ADA Curb Ramp New Construction Inspection Form (Perpendicular)

Nw 292nd

23885.56

Nw Fair

PERPENDICULAR RAMP (PR)

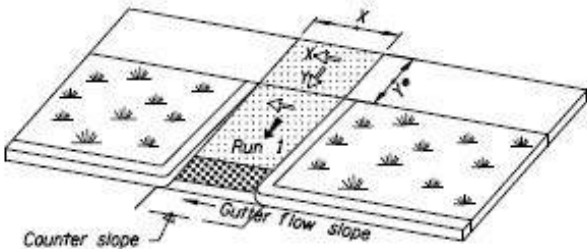
IITD RR1 Fails
